**ADDENDUM NO. 04**  
**January 28, 2022**

To Drawings and Specifications dated December 17, 2021

**CLINE ELEMENTARY SCHOOL CAMPUS REPLACEMENT**  
**FOR FRIENDSWOOD I.S.D.**

Prepared by: PBK  
11 Greenway Plaza, 22<sup>nd</sup> Floor  
Houston, TX 77046-1104  
PBK Project No: 20380

10 SECTION AT TYP READING NOOK  
1" = 1'-0"

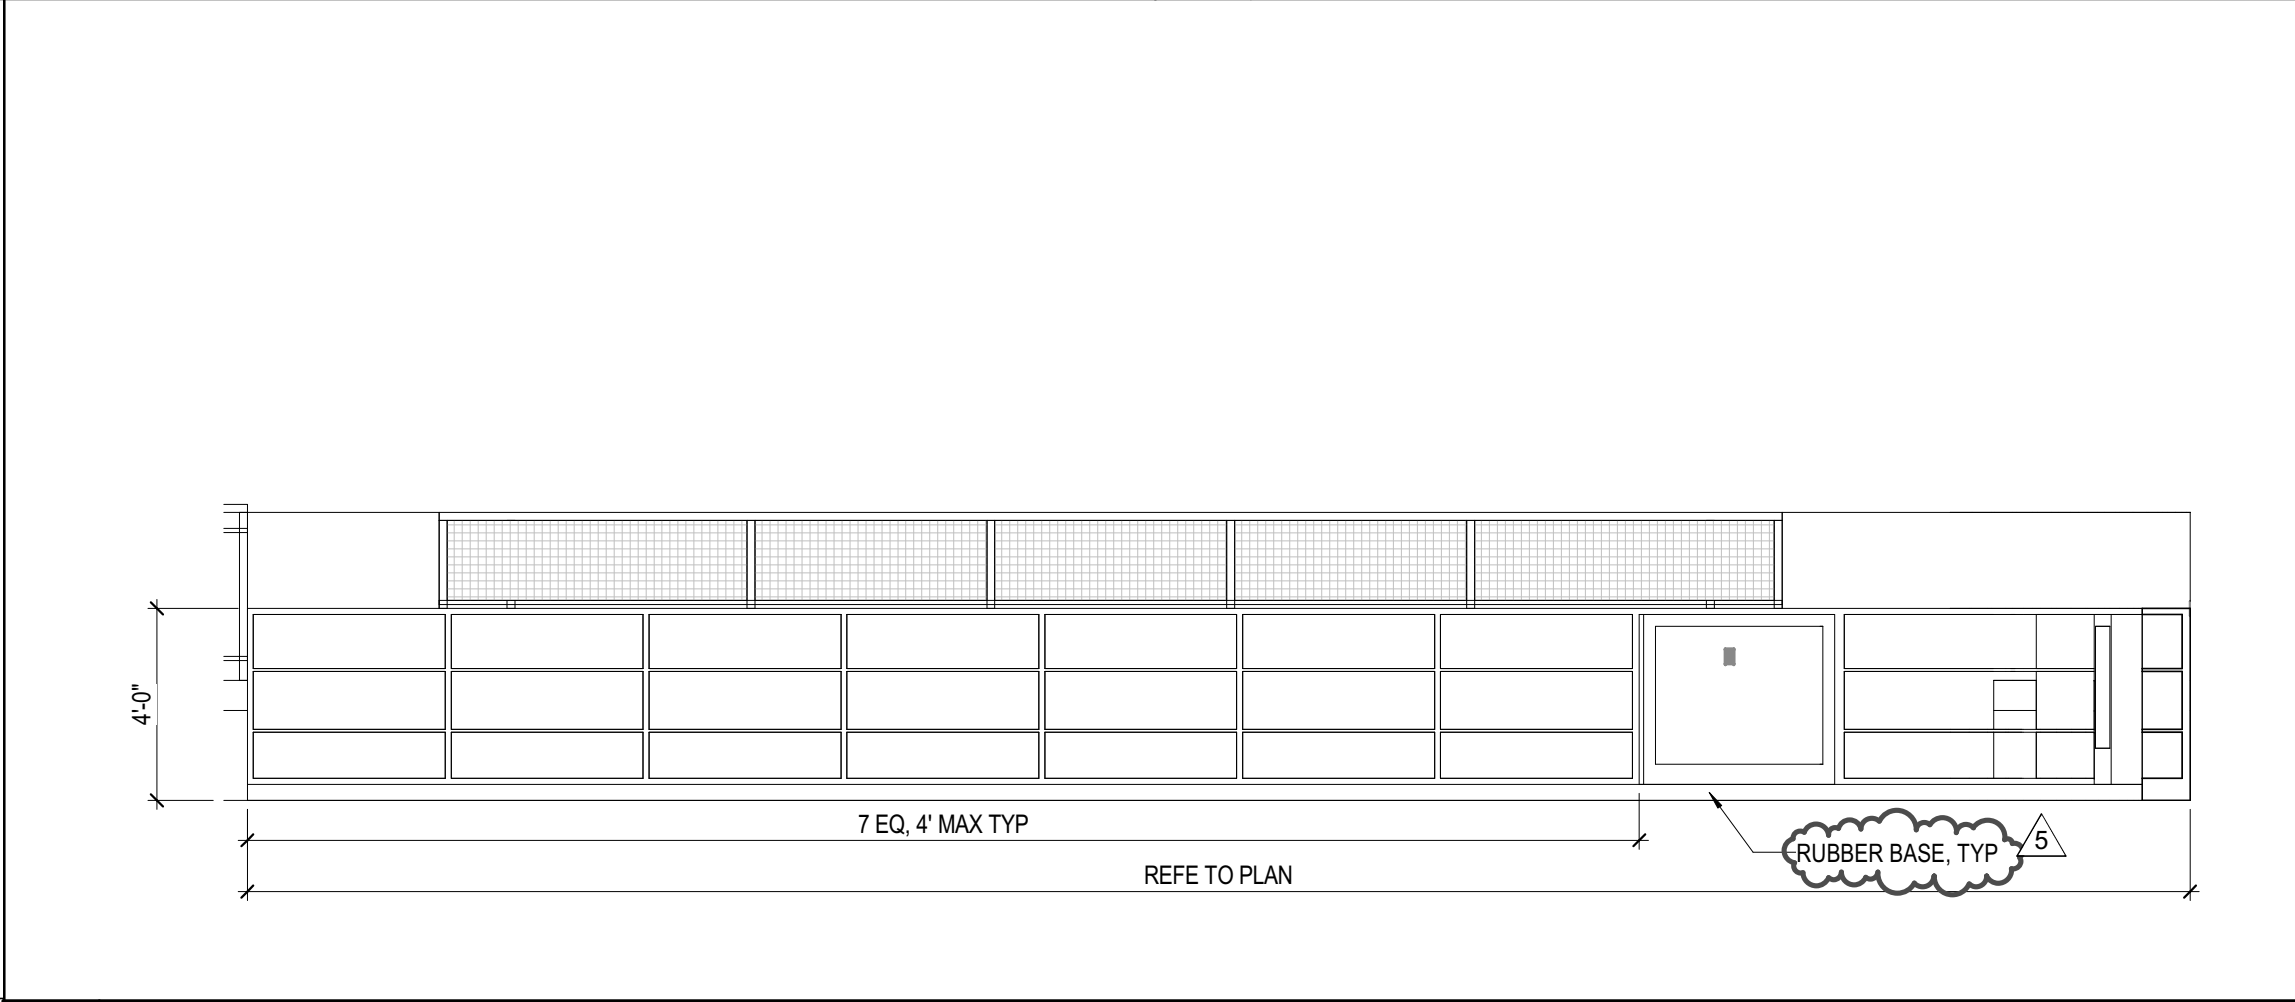
- Item No. 2      Revised Architectural Keynote 7 from ‘**MOTORIZED OVERHEAD COILING GRILLE**’ to ‘**MOTORIZED OVERHEAD COILING DOOR**’
- Item No. 3      Added Fabric upholstery UPH-1 on Material finish schedule.  
a. UPH-1: DESIGNTEX BEGUILLED BY THE WILDS, COLOR: GECKO (READING NOOK)
- Item No. 4      Revised ‘W-1’ tag to ‘WT-1’ on Room finish Schedule.

05 SECTION AT BENCH BELOW STAIR  
1" = 1'-0"

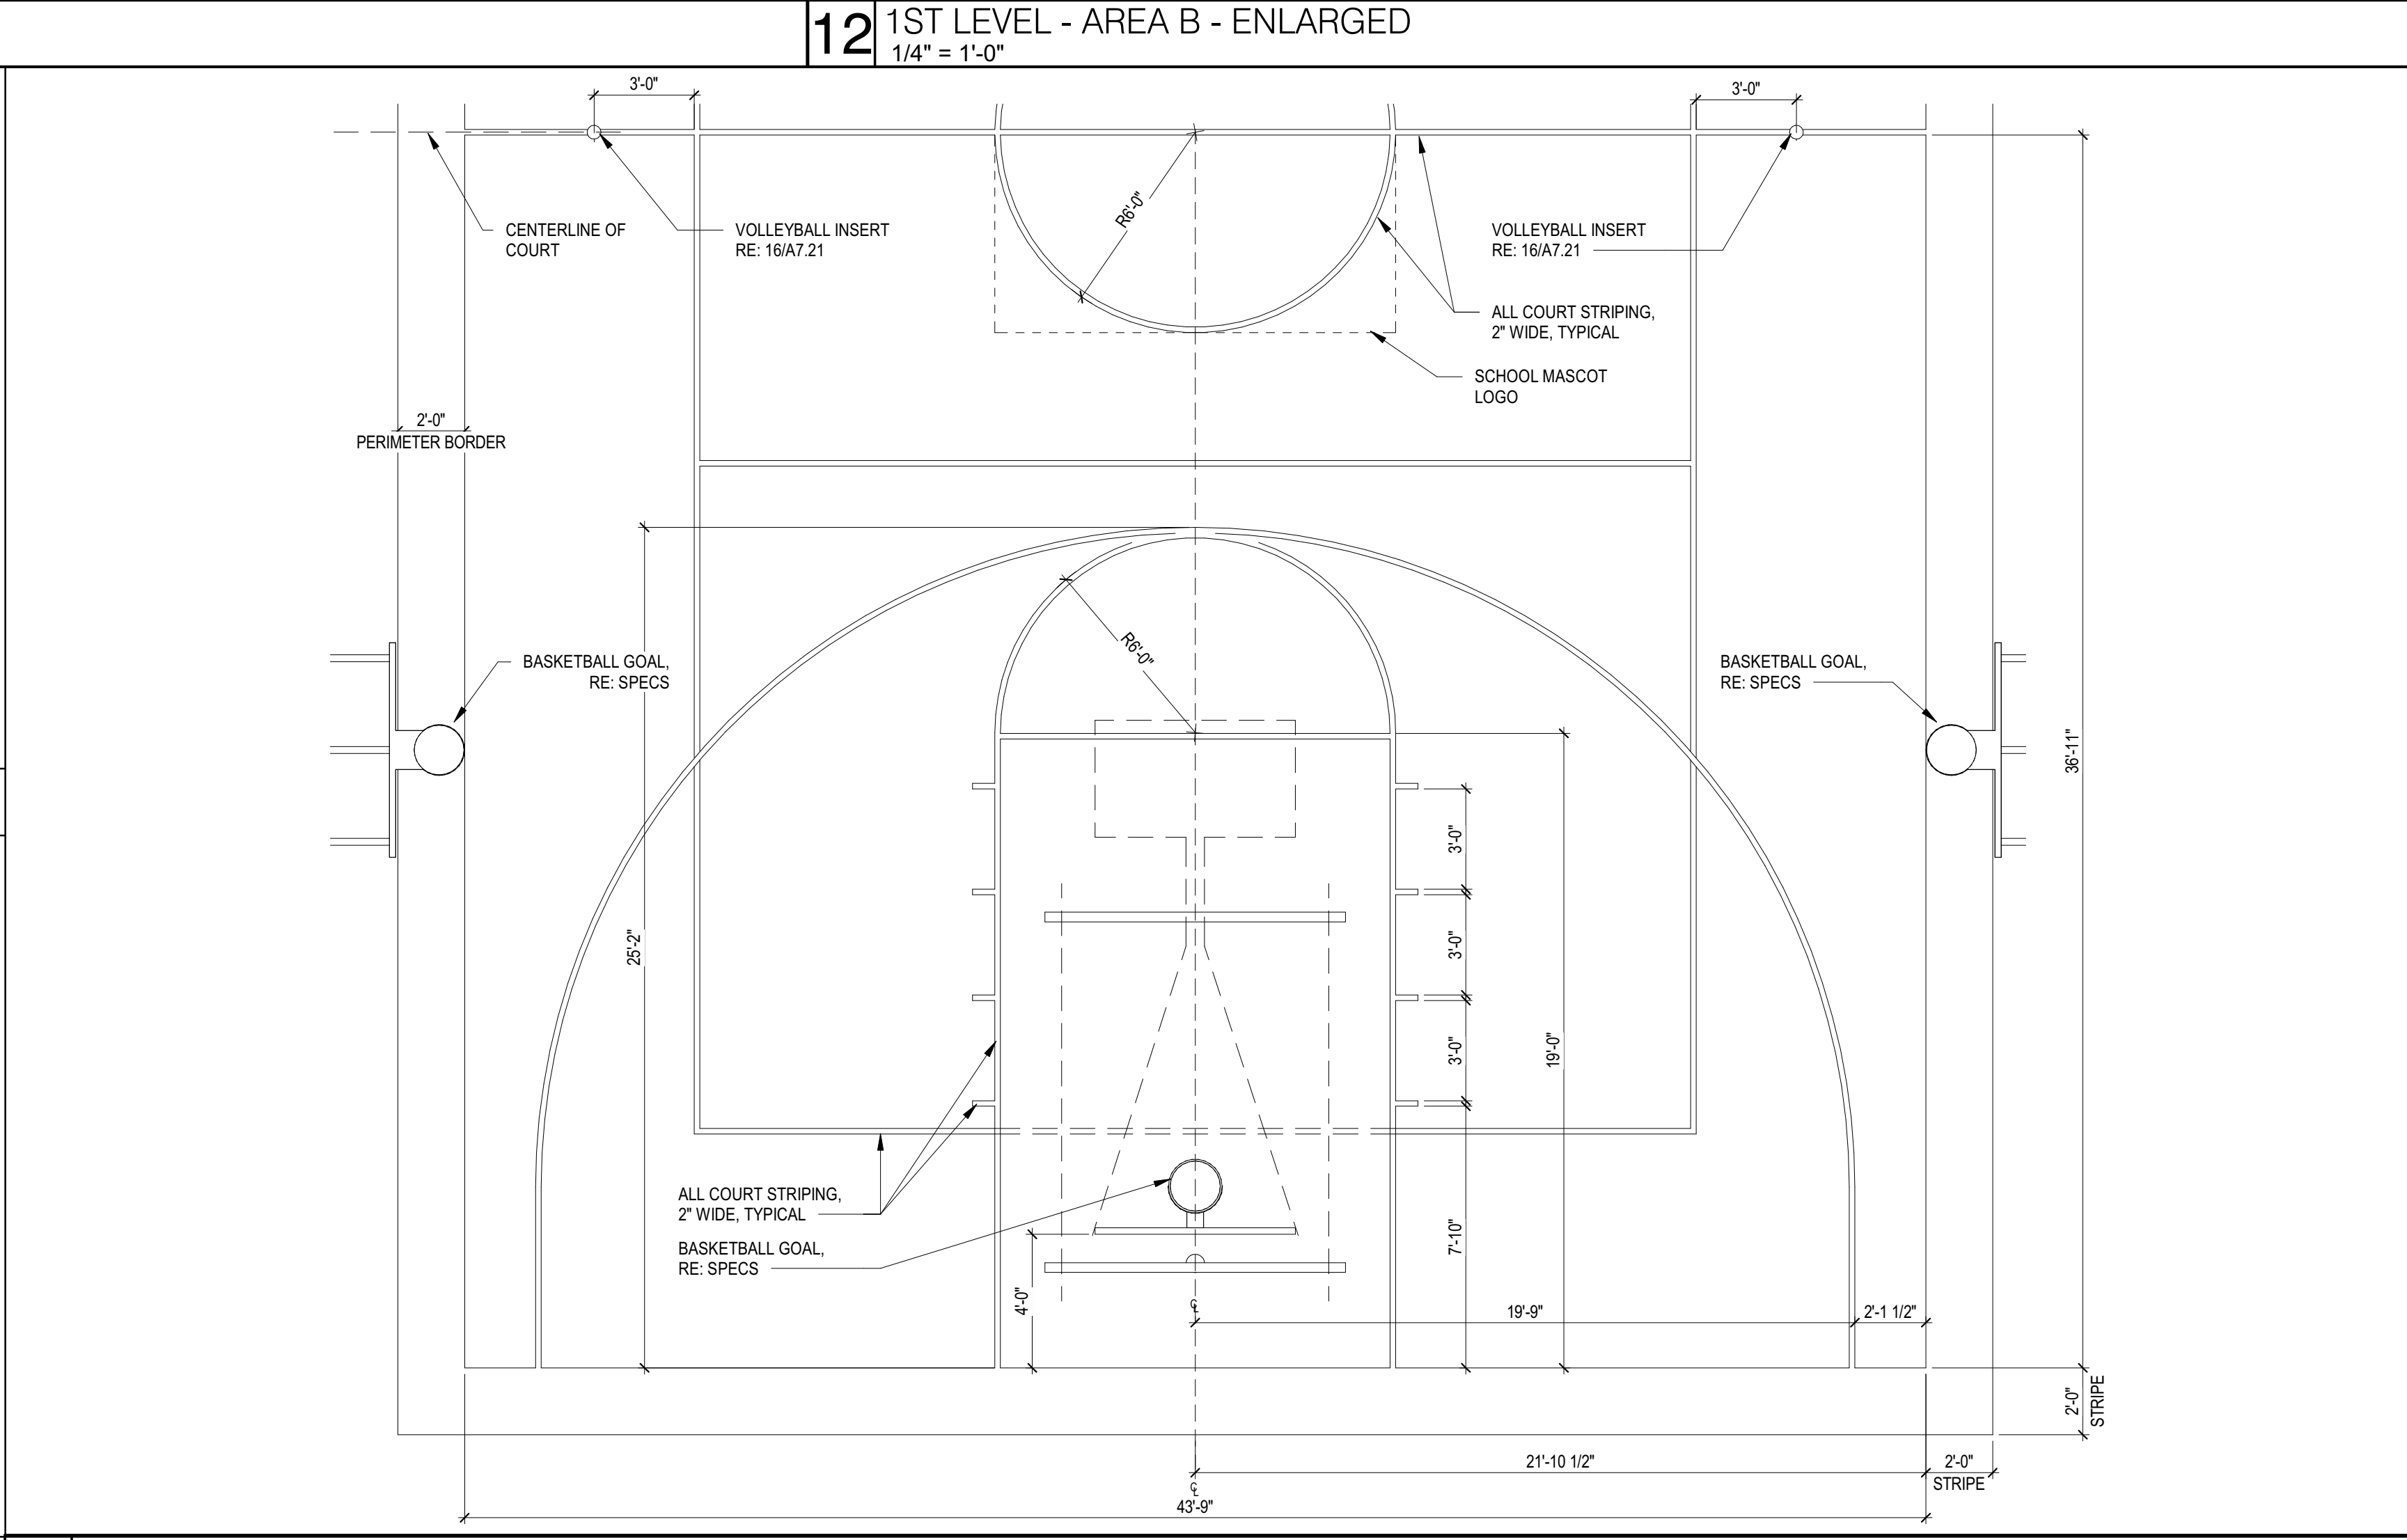
- Item No. 4      **AS303 SITE DETAILS**  
a. Added note on 13/AS303, ‘Entire structure to be galvanized with Kynar finish. Finish color to be Dark Bronze.’  
b. Revised note on 11/AS303, ‘Standing seam metal roof system’.
- Item No. 5      **A-101F1 1<sup>ST</sup> LEVEL – SCHEDULES – AREA F**  
a. Revised room finish schedule.
- Item No. 6      **A-101G1 1<sup>ST</sup> LEVEL – SCHEDULES – AREA G**  
a. Revised room finish schedule.
- Item No. 7      **A-102B1 2<sup>ND</sup> LEVEL – SCHEDULES – AREA B**  
a. Revised room finish schedule.
- Item No. 8      **A-421 ENLARGED STAIR PLANS, SECTIONS & DETAILS**  
a. Revised dimensions for the millwork bench below the stairs.  
b. Added bench section detail.
- Item No. 9      **A-451 ENLARGED PLANS & ELEVATIONS**  
a. Added 05/A-451 bench section detail.  
b. Added rubber base notes on built-in millwork bookshelves.  
c. Added note UPH-1.
